# C149 Function 15 module.

The C149, function 15 module has been developed to give additional functions to the Cinemation 2000 series Automation. The unit is easily retrofitted to the existing logic board and only requires connections to the sound control system.

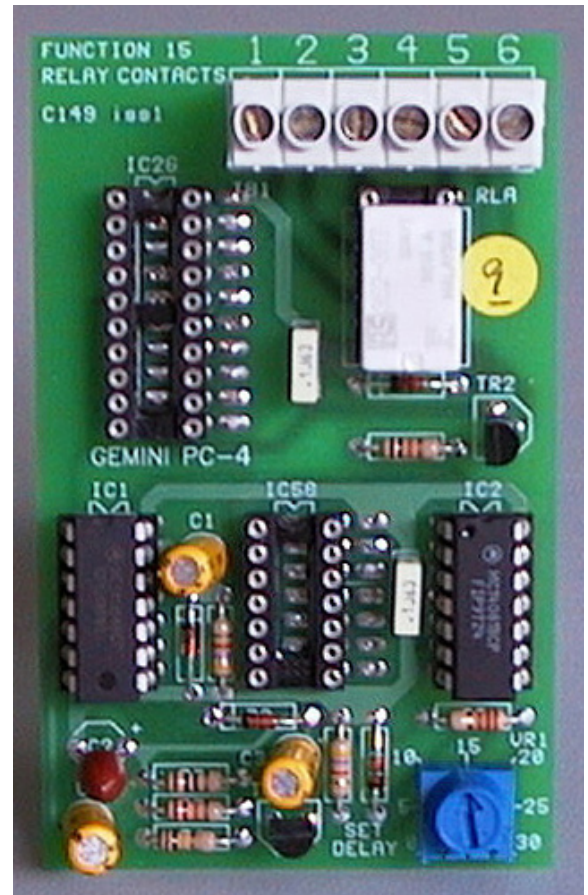
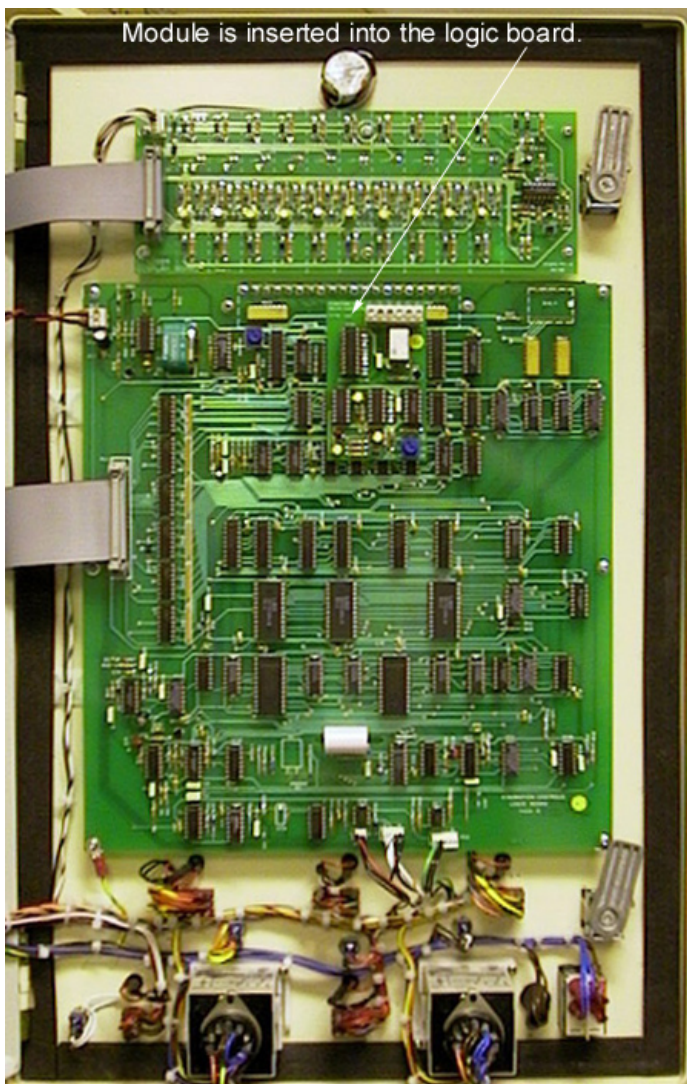
- Interior function 15 now becomes available for sound format change.
- Function 10 has additional timer delay for tabs close.

Function 15 was previously an internal only operation but becomes available with the introduction of the new circuitry.

A two pole make / break 1 amp relay is now available when function 15 is selected.

Function 15 can be used for sound mute or sound format change by direct connection to Dolby systems.

Function 10 internal routine, now has an additional variable time delay (0-30s), which is controlled by the blue onboard potentiometer.

This time delay occurs immediately before all previous functions and is used to compensate for differing tab closing times.
